ADDENDUM NO. 03

**Kalamazoo Public Schools Loy Norrix High School Mechanical Improvements
606 East Kilgore Road
Kalamazoo, MI 49001**

ADDENDUM NO. 3

PROJECT: Loy Norrix High School Mechanical Improvement D Wing
606 East Kilgore Road
Kalamazoo, MI 49001

SHEET NUMBER
M 201D1

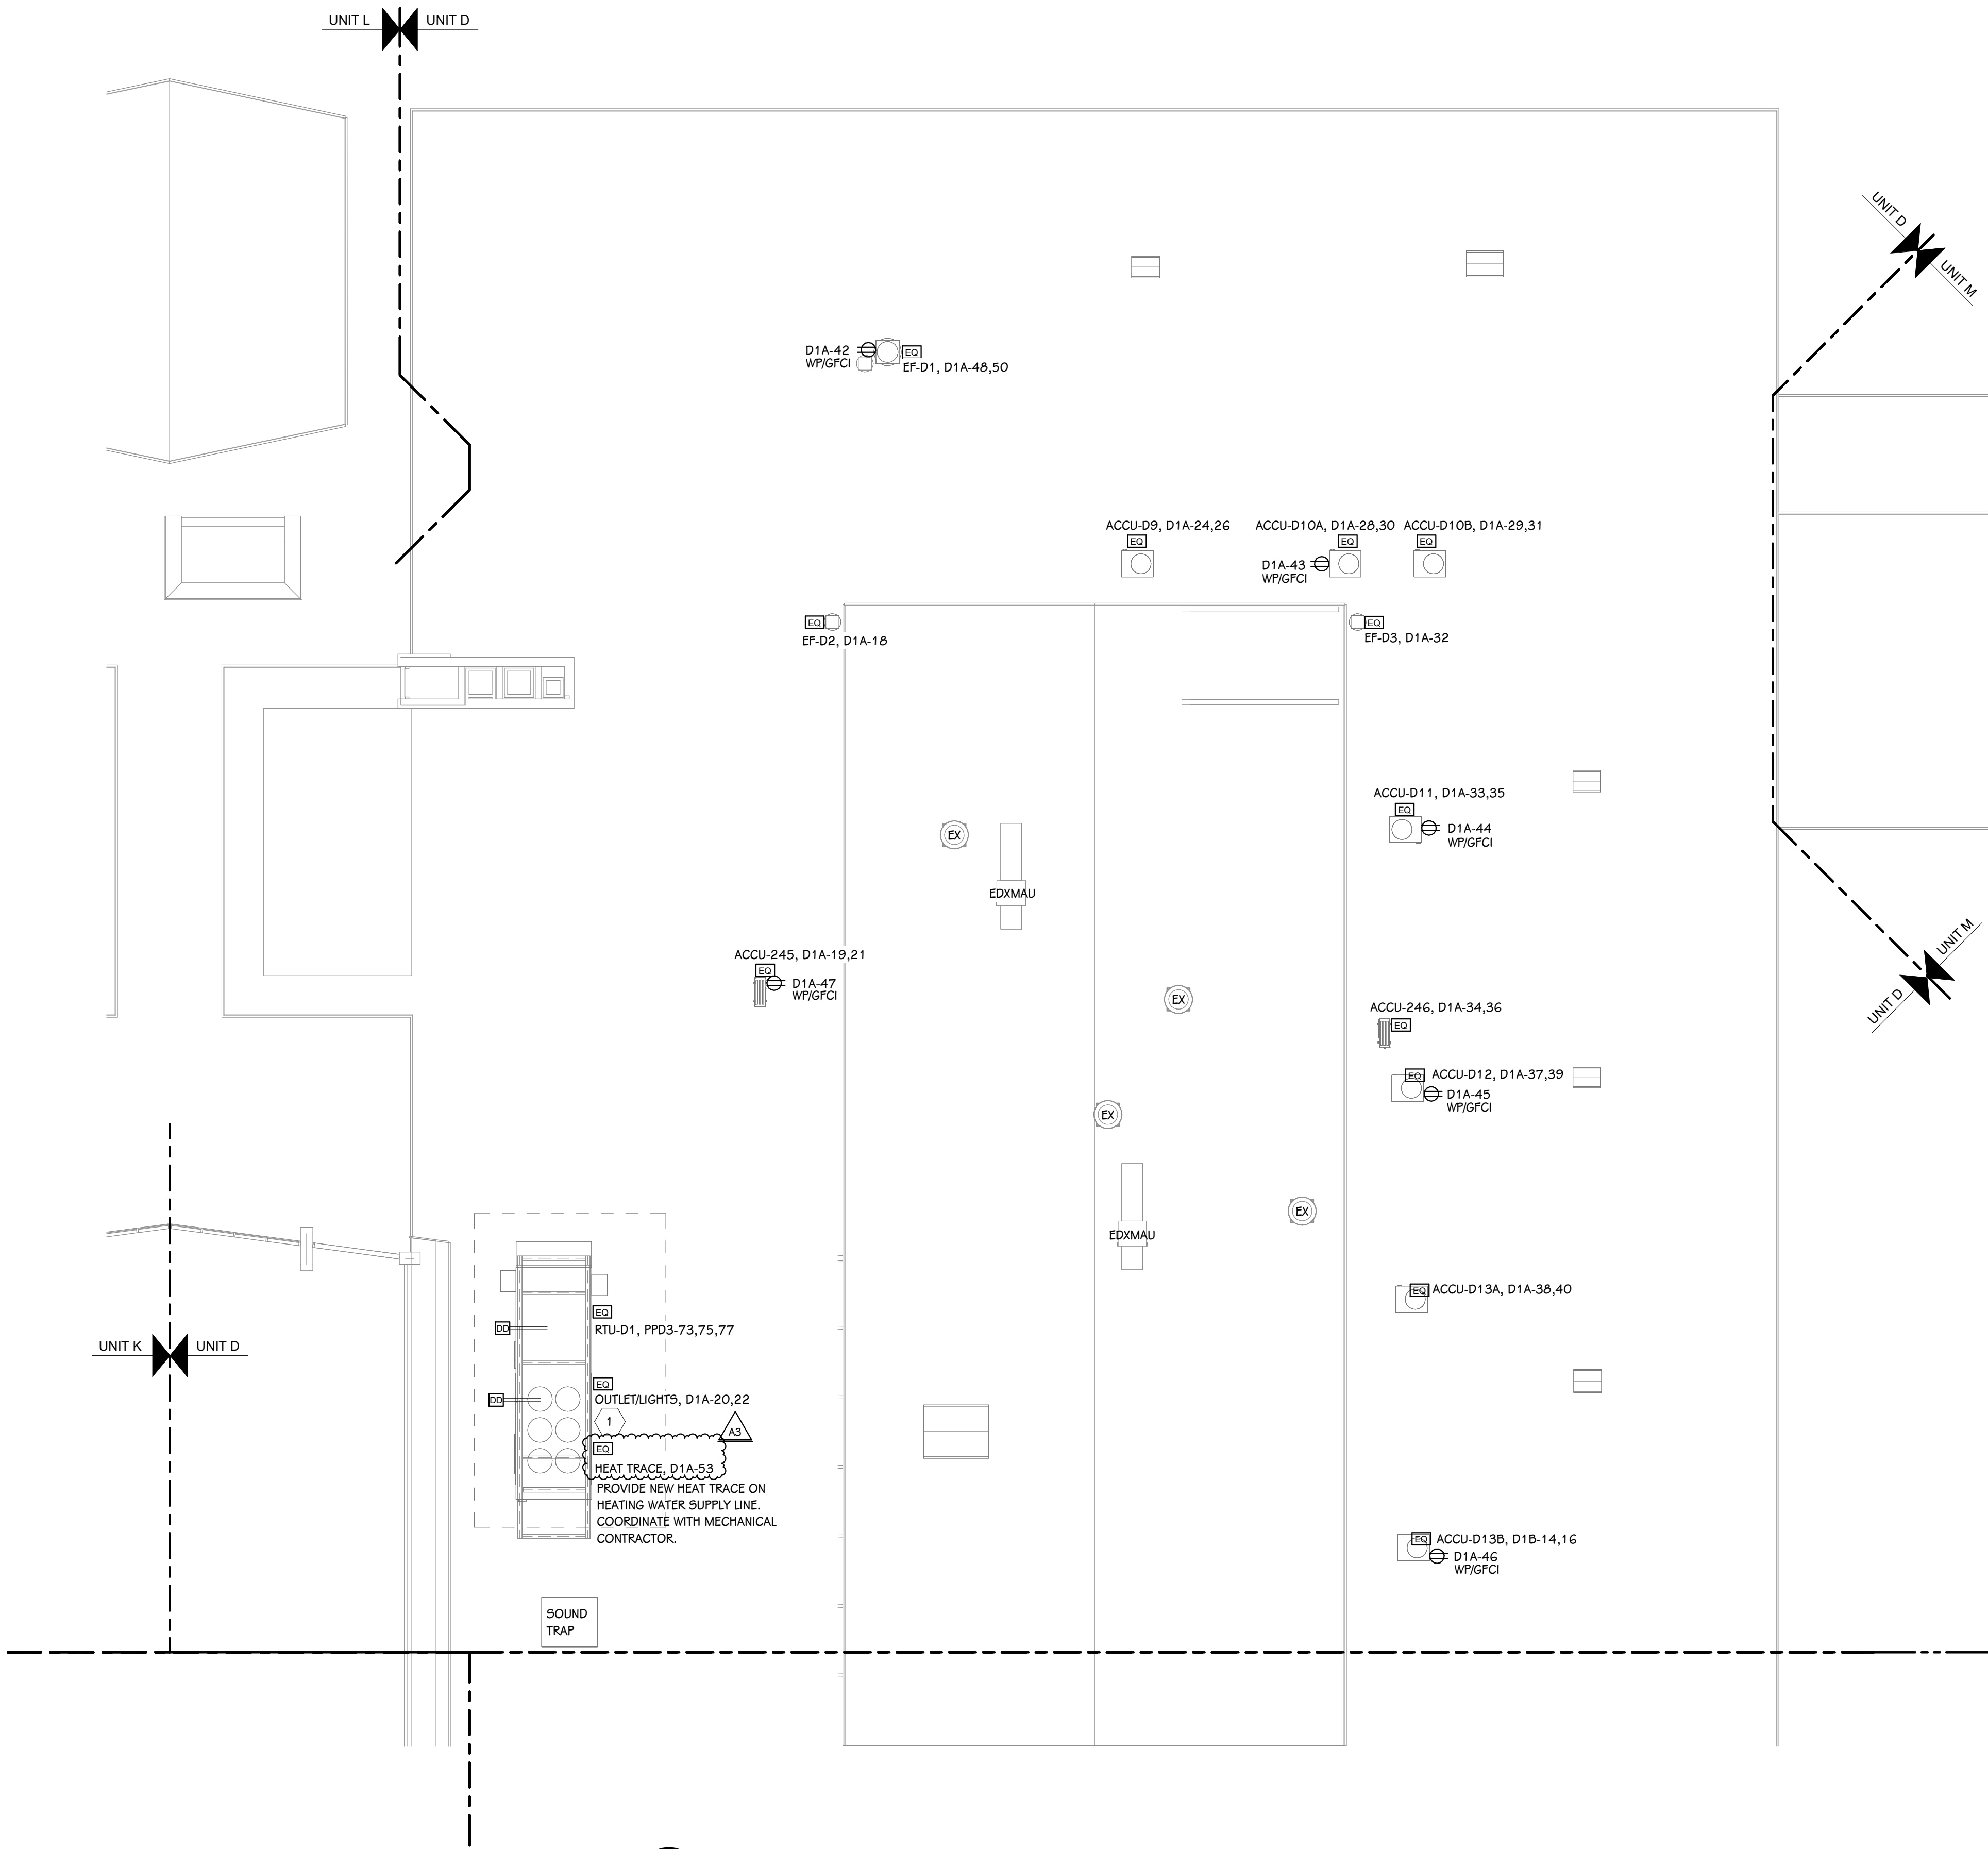
ADD-3 Item No. D-4 - Updated Pipe Locations

Relocated piping in Classrooms D-11 and D-13, refer to drawings above for new locations.

ADD-3 Item No. D-5 - Added Horizontal Pipe Chase

Added a clear anodized aluminum chase to run inside casework to enclose mechanical piping.

SHEET NUMBER
E 150D1
23-637.00

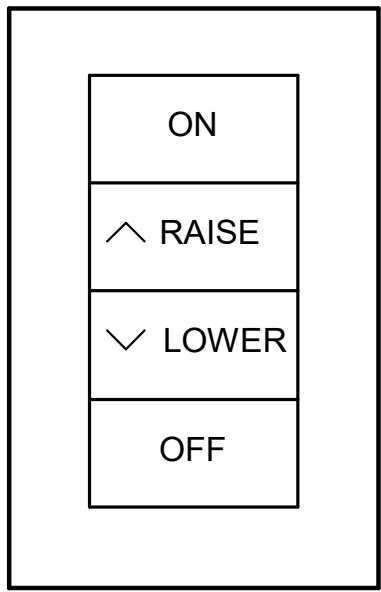
ADD-3 Item No. D-6 - Added Heat Trade Circuit

Added circuit for heat trade to RTU-D1. Revised panelboard schedule D1A with new circuit.

TECHNOLOGY SCOPE SHOWN ON THIS SHEET IS FOR REFERENCE ONLY AND IS PART OF A SEPARATE PROJECT #23-650.014

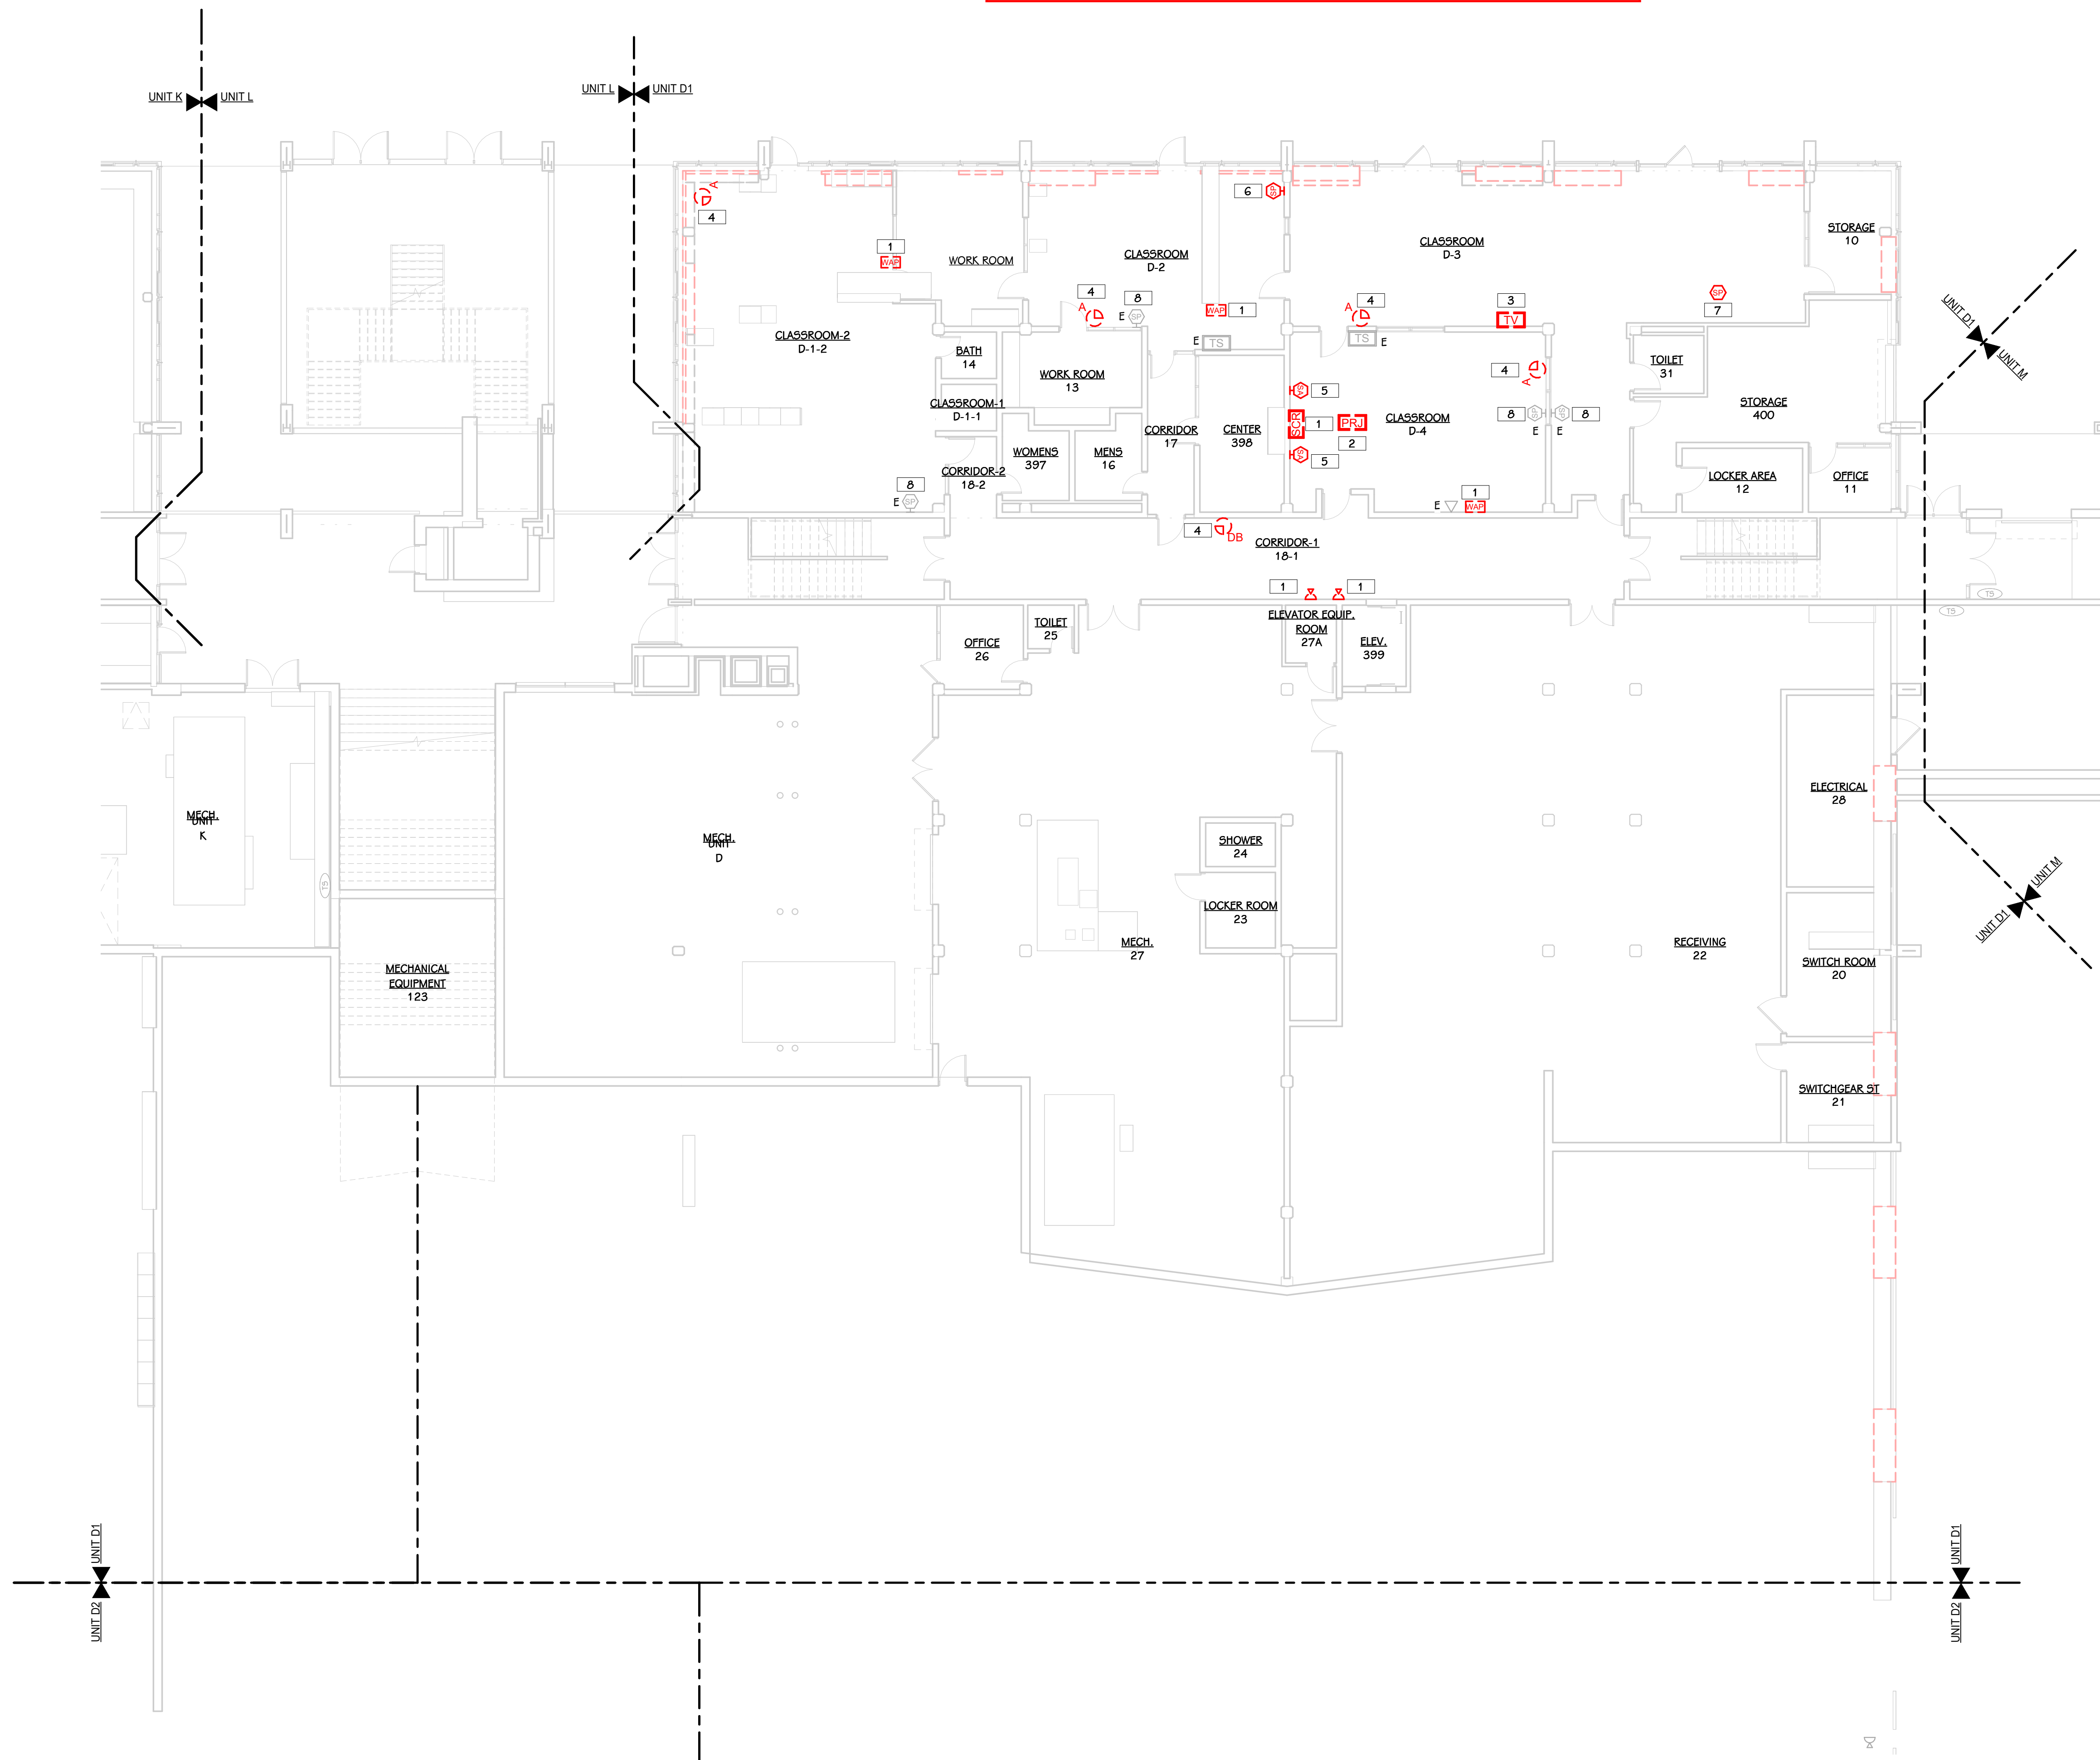
Refer to Sheet(s): TD 100D1, TD 101D1, TD 101D2, T 100D1, T 101D1, T 101D2

Updated the AV equipment storage location to Loy Norrix High School for the Technology Contractor. All technology "T" sheets are for reference only. Refer to updated keyed notes.

- 1 DEVICE SHALL BE REMOVED AND RETURNED TO LOY NORRIX HIGH SCHOOL STORAGE. COORDINATE STORAGE LOCATION WITH KPS FACILITIES. DOCUMENT CABLE ID, MAC ADDRESS, # DEVICE LOCATION. COIL CABLE AT CEILING FOR FUTURE INSTALLATION.
